Re: West Ridge Mine C/007/041
Culvert Replacement

Please see the included 2 Clean Copies for the amendment to the West Ridge Mine C/007/041 MRP to replace a culvert and clean up the text in Appendix 7-4. The associated map is included.

WEST RIDGE MINE
Map 7-2
Mine Site Drainage Map

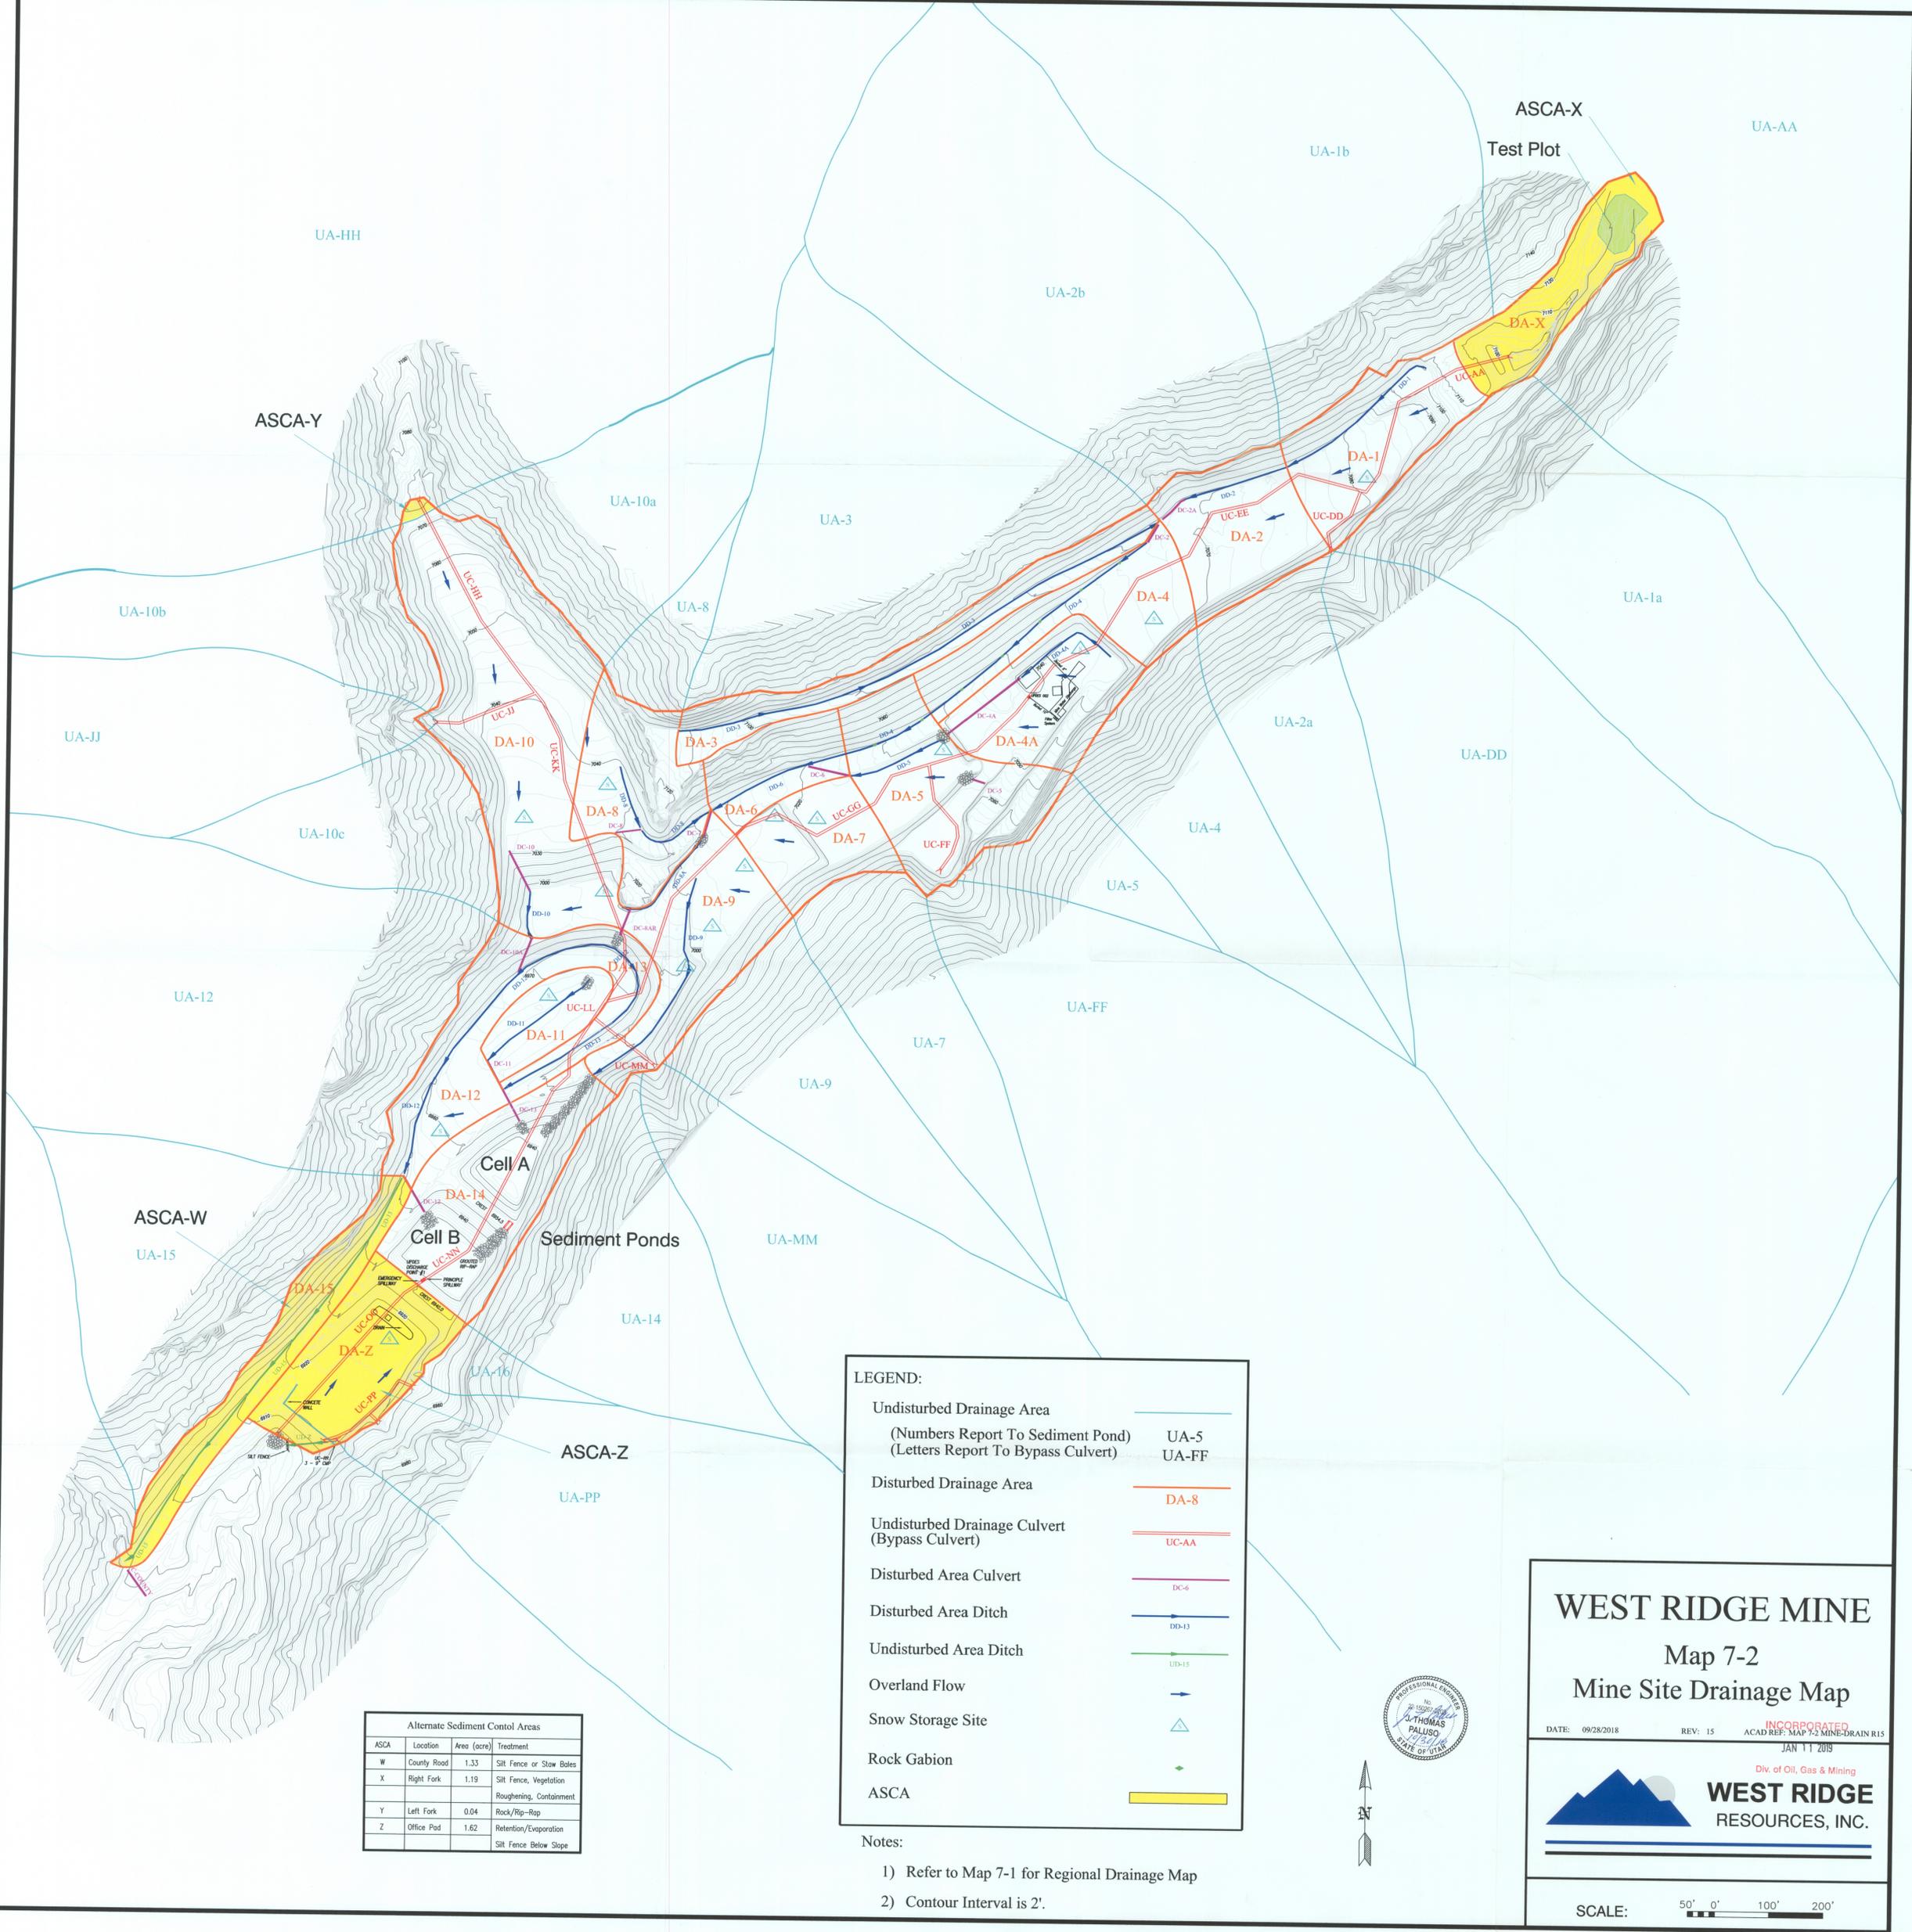
- f) In 2003, DC-8AR was designed and installed to serve as a relief culvert to DC-8A due to its continual maintenance issues. In 2008 it was determined that DC-8A was poorly designed and was ultimately installed in a location which was hindering mining operations, and so it was removed. DC-8AR is now used in place of DC-8A.

DC-8A replaced by DC-8AR
